**RESIDENTIAL ACCESSORY STRUCTURES / FENCES / EXTENSIONS / REVISIONS  
PLAN APPLICATION and APPROVAL**

Property Address 467 W. Ventura Dr.

The PUEBLO WEST COMMITTEE OF ARCHITECTURE, INC. has reviewed subject submittal on this date and has approved said plans for 362-4-5 subject to the conditions checked and noted herein:

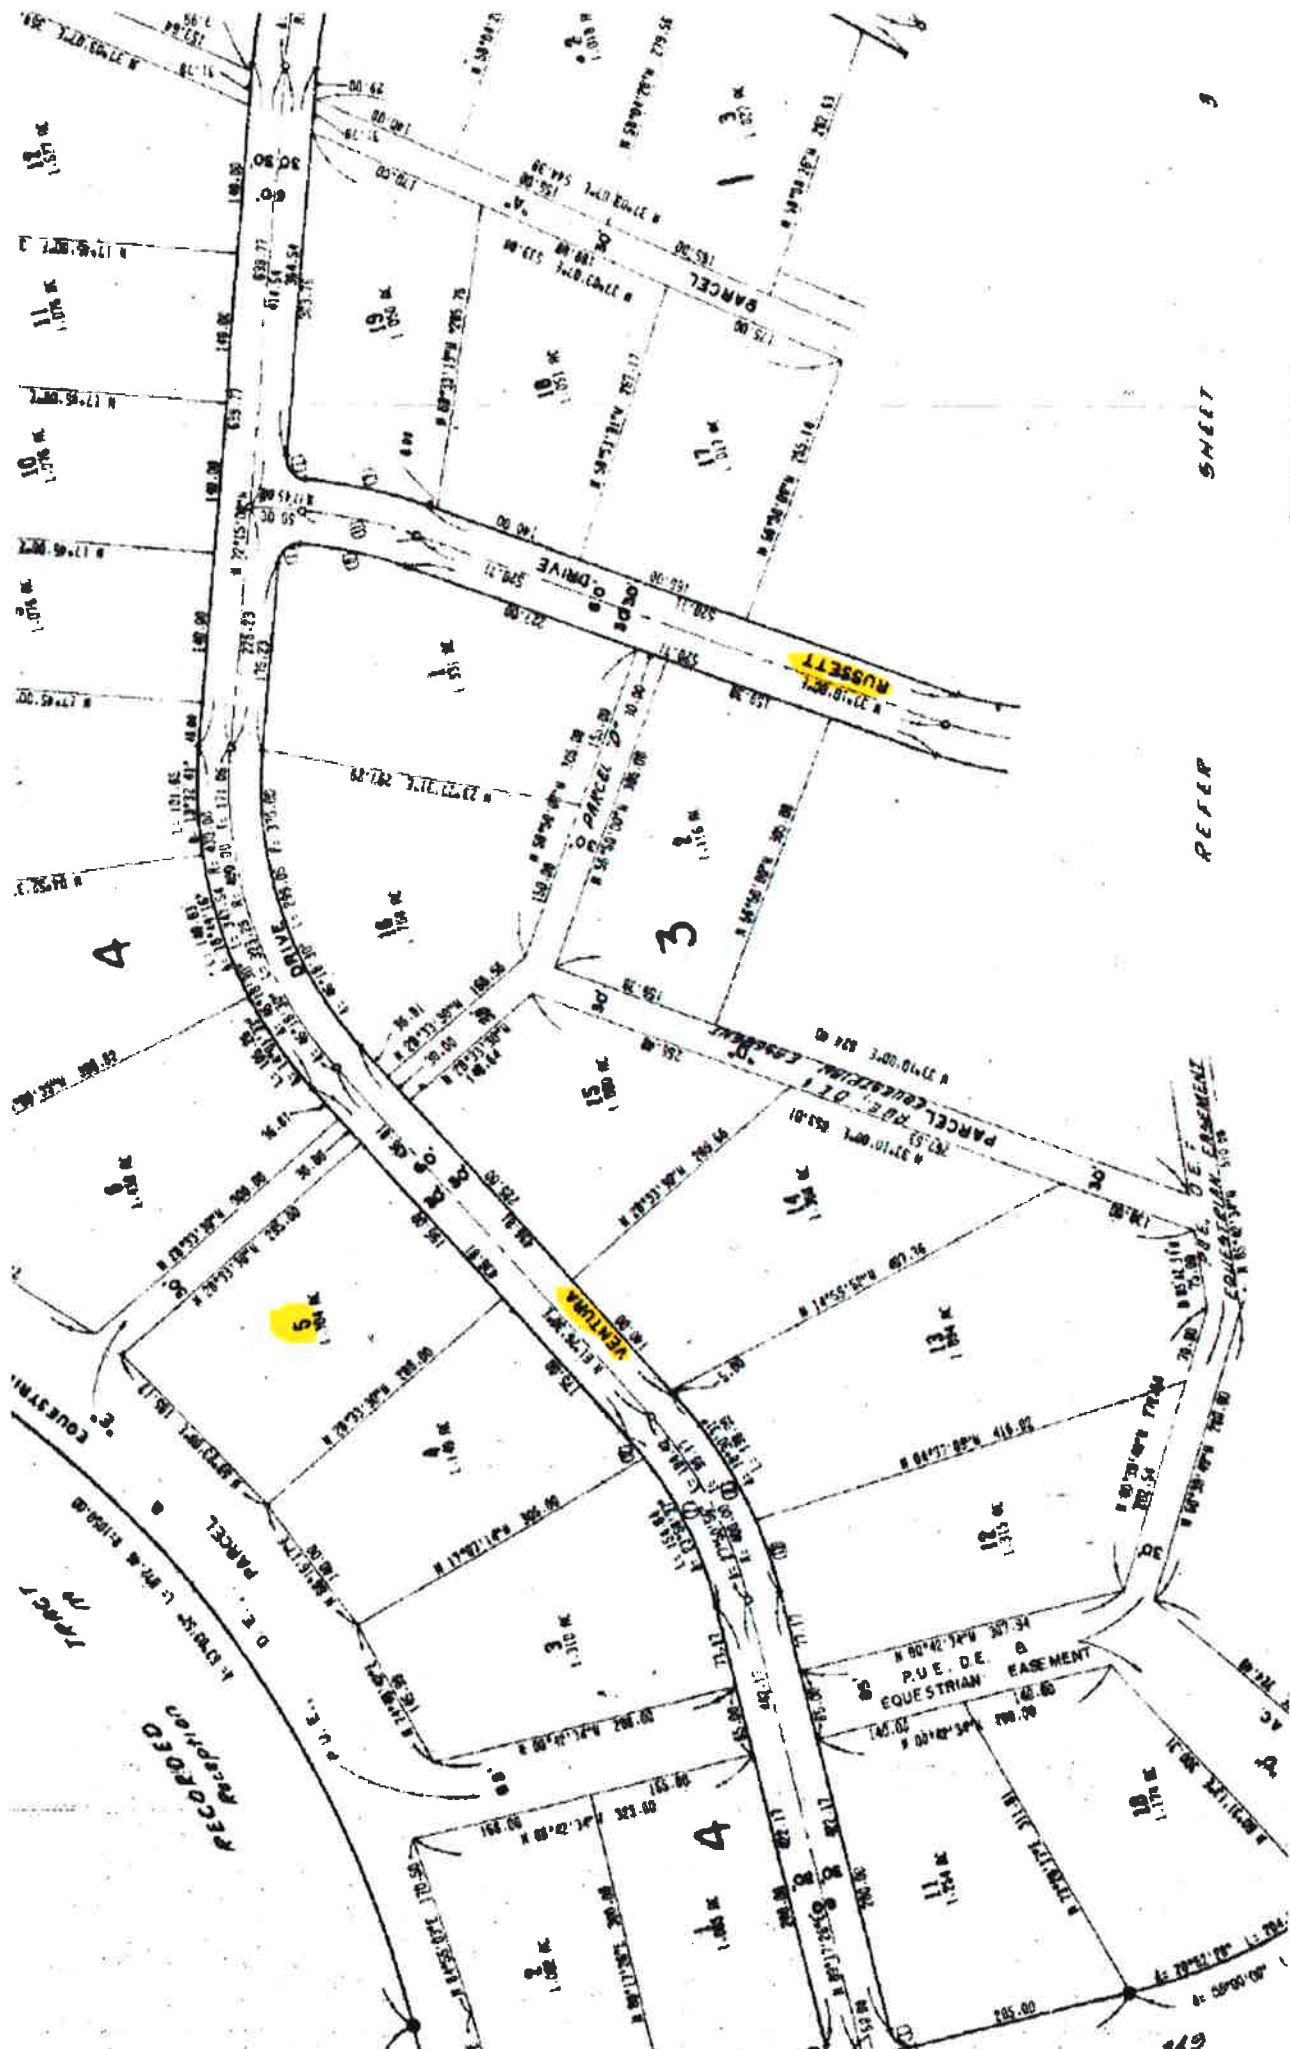
- 1. Submission of a stamped foundation plan to the PWCD office prior to excavation (additions, garages, if appropriate).
- 2. The approved landscaping plan (to include at least twenty-five (25) feet around the house, and all area disturbed by construction, is complete by 10/9/20 and the landscaping, including natural areas, is maintained thereafter. Any land disturbed beyond the scope of the landscaping plan shall be reclaimed with ground cover approved by the PWCOA. Until the landscaping is complete, weeds will be cut and kept under control.

- 5. The horizontal support boards and the vertical posts for the fence are constructed to the inside of the property, or in a shadow box manner.
- 7. The accessory building addition is colored to match the dwelling and detached structures do not exceed <sup>15'</sup>~~30'~~ in height.

- 9. Construction is completed within 180 days 90 days 60 days of the approval date of 4/9/20.

OTHER: The building is required to have at least 6" overhangs or gutters.
